CITY OF WESTMINSTER				
	Date	Classification		
APPLICATIONS SUB COMMITTEE	23/10/2018	For General Rele	ase	
Report of		Ward(s) involved		
Director of Planning		Abbey Road		
Subject of Report	10 Ryder's Terrace, London, NW8 0EE			
Proposal	Erection of new pitched roof with rooflights at main roof level and replacement of lantern light with two rooflights in roof of rear ground floor extension.			
Agent	Mr Chris Smith			
On behalf of	Mr Conor Scanlan			
Registered Number	18/06819/FULL	Date amended/	10 August 2010	
Date Application Received	13 August 2018	completed	13 August 2018	
Historic Building Grade	Unlisted			
Conservation Area	St John's Wood

**Proposal:** Erection of new pitched roof with rooflights at main roof level and replacement of lantern light with two rooflights in roof of rear ground floor extension.

**Reference:** 18/06819/FULL

Application site (10 & 11 Ryders Terrace)

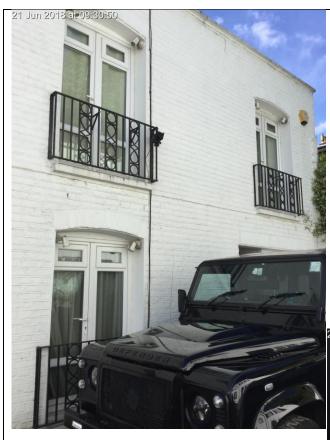
View of application site looking from No. 36 Blenheim Terrace

# 9. KEY DRAWINGS

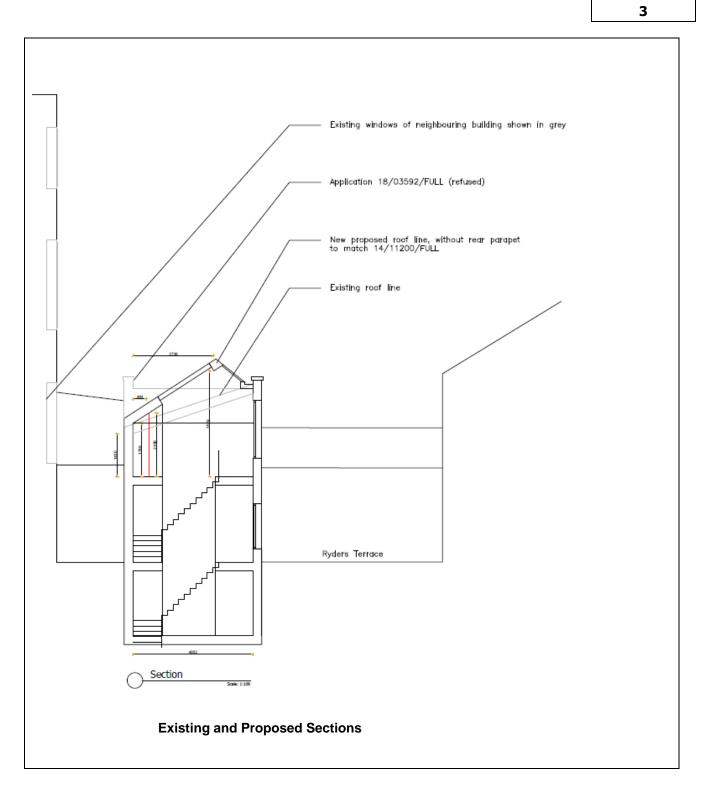
- Proposal will alter the skyline and is out of keeping of the mews area
- Height of the flat roof raised
- Drawings do not specify materials to be used for flat roof
- Rooflight on front roofslope can be seen from Ryders Terrace

- Loss of light
- Loss of privacy
- Noise disturbance and light pollution from rooflights
- Potential future use of the flat roof as a terrace once the lantern is removed
- Terrace will result in noise disturbance

- Inaccuracies between the submitted application form description of development and the drawings in regards to the roof and the number of rooflights proposed
- Void annotated on drawings is mischaracterised
- Request that applicants install adequate rain gutters to the rear elevation
- No service pipes, vents, extractors to be put on side elevation.
- Space described as void on plans is a well-used courtyard amenity space.

The 3 x rooflights proposed on the rear part of the roof of this building has the potential to overlook the windows of the rear elevation of Blenheim Terrace. The applicant has confirmed in an email and since annotated the proposed drawings to illustrate obscure glass would be used in these rooflights. The existing building has two rooflights and a glazed section of roof towards the west end of the site, however the steeper pitch of the roof proposed has the potential to increase overlooking. It is therefore considered reasonable to attach a condition to any permission granted requiring the rooflights are obscure glazed and fixed shut.

4 The glass that you put in the glazed area of the roof hereby approved to the rear of the property facing number 36 and 38 Blenheim Terrace must not be clear glass, and you must fix it permanently shut. You must apply to us for approval of a sample of the glass (at least 300mm square). You must not start work on the relevant part of the development until we have approved the sample. You must then fit the type of glass we have approved and must not change it without our permission. (C21DB)

5 The hereby approved rooflights shall be conservation grade rooflights and maintained as such thereafter.

6 You must not use the roof of the rear ground floor extension of the property for sitting out or for any other purpose. You can however use the roof to escape in an emergency.
